Final Drainage Report

Lot 4, Barbarick Subdivision El Paso County, Colorado

Project #: 196489000

Prepared: December 5, 2023

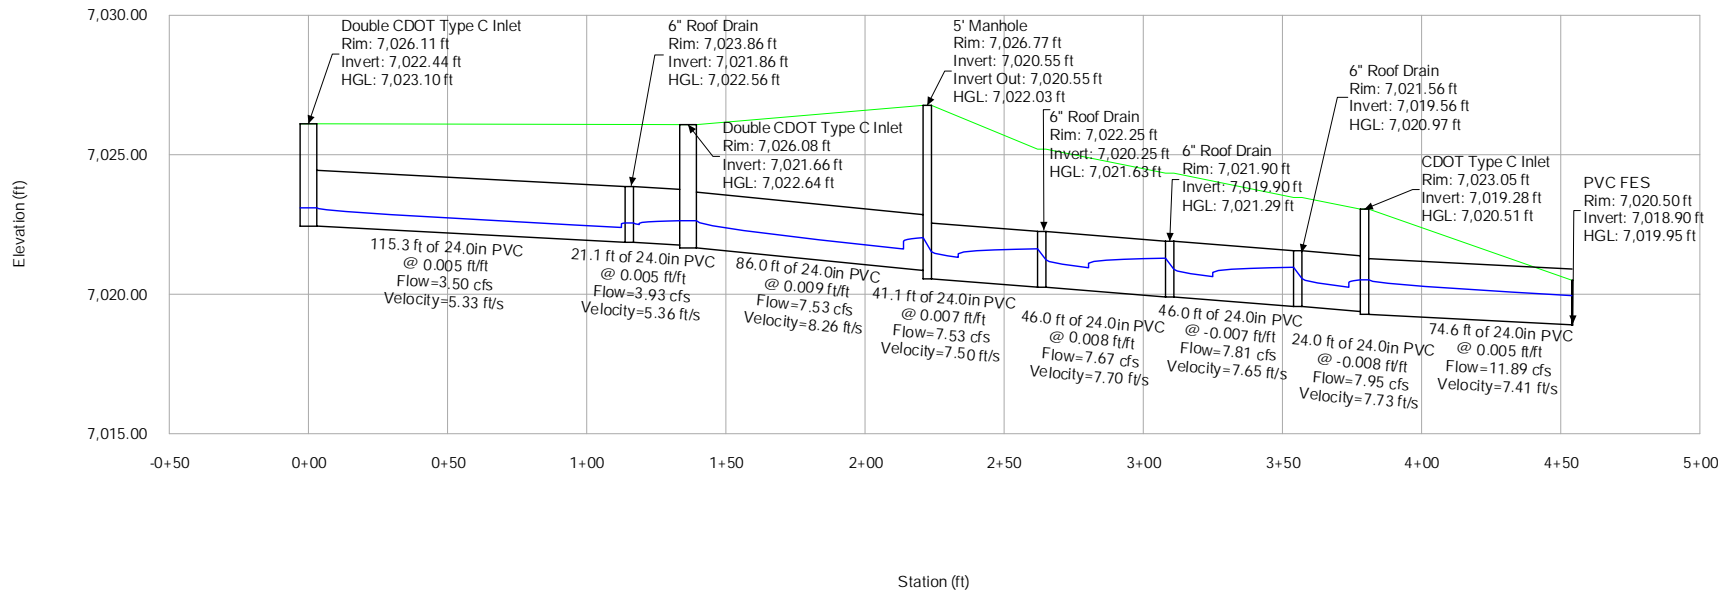
Please clarify this math more with a reference to an appendix for example. Or provide a comparison table here in this text (historic vs original design vs proposed design flowrates). Because this math does not coincide with the total flowrates shown on PDF pg 82 below.

Also update this paragraph per any updates to the table on pg 82 below per my comment on that page.

Note that crushed asphalt has been installed across most or all of these basins. The County considers crushed asphalt to be 100% impervious. Please revise these values accordingly. And then adjust the report discussion above with the subsequent new Total runoff values.
